PRELIMINARY DRAINAGE REPORT

Storyrock Phase 2

Plan #	_____
Case #	<u>5-PP-2016#4</u>
Q-S #	_____
<input checked="" type="checkbox"/> Accepted	
<input type="checkbox"/> Corrections	
<u>N. Baronas</u>	<u>10/3/17</u>
Reviewed By	Date

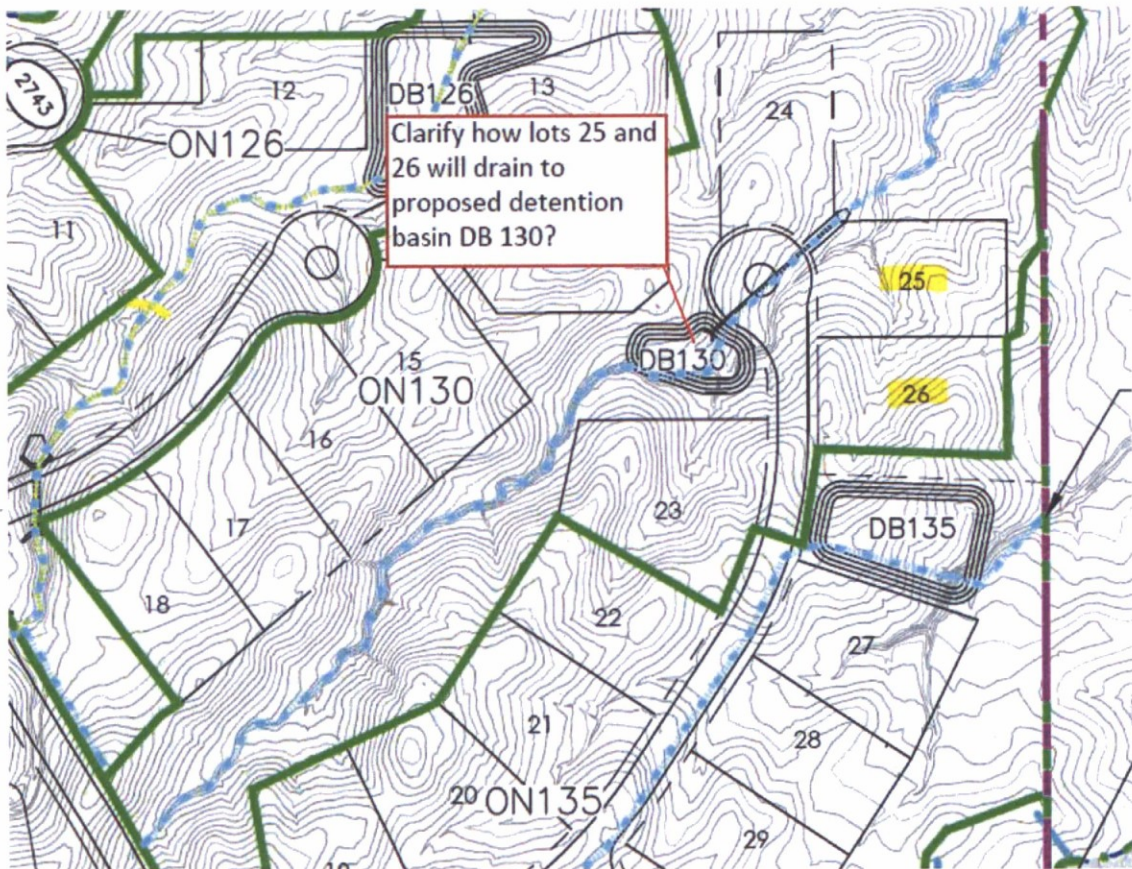
16. **COS 1<sup>st</sup> Review:** Submit analysis documenting how RTIMP is derived for post development condition HEC-1 model. Add discussion to address LG record value differences between pre and post development conditions. Below you will find a sample basin analysis, which applies to number of basins analyzed with this submittal. Basin ON135 is Zoned Residential R1 18, modeling it with 24% impervious area appears to be low.

It should be noted that higher developed condition RTIMP values will result in higher developed condition runoff values, which will require larger on-site stormwater storage basins to attenuate the associated increases. This issue can have a substantial impact on the grading and drainage design and layout of the proposed project.

**COS 2<sup>nd</sup> Review:** Not addressed. Please review and address 1<sup>st</sup> review comment. Note, Maricopa County Drainage Policies and Standards, Table 6.5 identifies RTIMP of 30% for R1-18 zoning. Based on our experience, full build-out condition in Scottsdale typically results in a higher percent of impervious area when compared to the same zoning in the County.

**KHA Response:** Per discussion with the City at meeting held Tuesday, January 10, it is our belief that our selected land use values are appropriate for the proposed development. They are in-line with, and more conservative than the county land use parameter for similar zoning/lot sized. It is important to note, that the R<sub>time</sub> value is not comparable as a Rational method run-off coefficient. Furthermore, when looking at the weighted R<sub>time</sub> for a sub-basin, please note that many of the subbasins include portions of desert land use, which further reduce the weighted R<sub>time</sub> value of the entire subbasin. A copy of Table 4.2 from the Drainage Design Manual for Maricopa County has been provided in Appendix B for representative land uses and RTIMP %'s.

**KHA 2<sup>nd</sup> Response:** As discussed with the City on April 12, a RTIMP comparison exhibit for each zoning category (R1-18, R1-35, and R1-43) has been provided to indicate that the percent impervious RTIMP selected for this project is appropriate and more conservative than calculating a weighted RTIMP for the entire development. The exhibits provided highlight the selected RTIMP for each zoning category versus a representative weighted RTIMP value for the development. The additional exhibits and reference to Maricopa County Drainage Policies and Standards should provide the background required by the City to support the selected RTIMP for the project.

Figure 4. Proposed Drainage Condition.

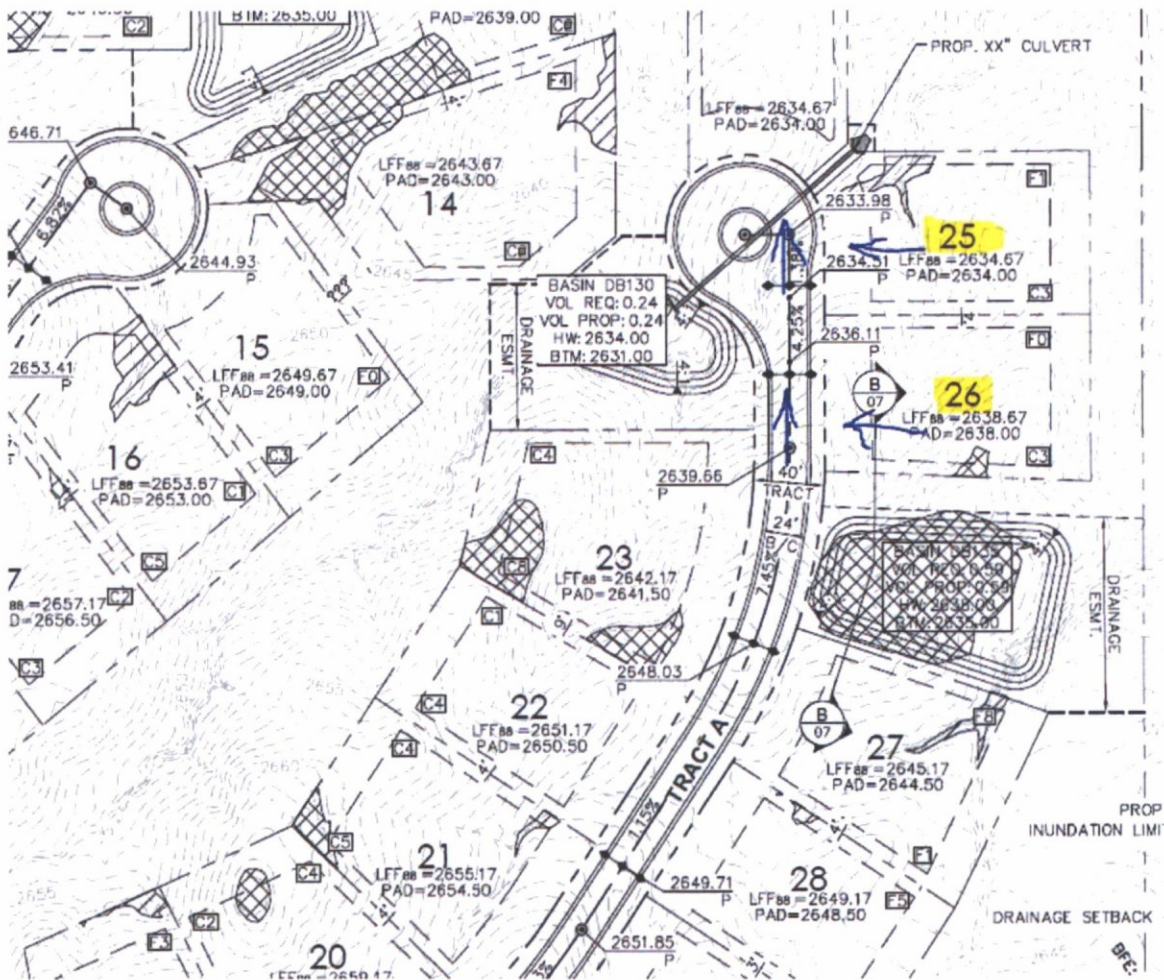
- COS 1<sup>st</sup> Review:** Provide sufficient level of information to demonstrate how proposed on-site watersheds will be routed through stormwater detention facilities. Add flow direction arrows to Figure 4, Proposed Drainage Condition map to clearly demonstrate intended flow patterns. HEC-1 model proposes routing of most watersheds through detention facilities in effort to reduce post development peak flows. See sample watershed below, how are the two northerly lots draining to proposed detention basin? Preliminary Grading and Drainage plan (sheet 5 of 7) does not show flow interception and routing to the proposed detention basin, that is not consistent with HEC-1 analysis.

**COS 2<sup>nd</sup> Review:** Please identify limits of disturbance associated with proposed swale and wash re-routing. Call out flow line elevations.

**KHA Response:** Figure 4 and preliminary grading plan have been updated to better show proposed routing of onsite flows.

**KHA 2<sup>nd</sup> Response:** Limits of disturbance associated with proposed swales and construction envelopes have been added to the plan in addition to the roadway grading limits previously shown. Swale flow lines have been revised to correspond with the disturbance limits more appropriately and contour labels have been increased to better review flow grades in comparison to adjacent improvements.
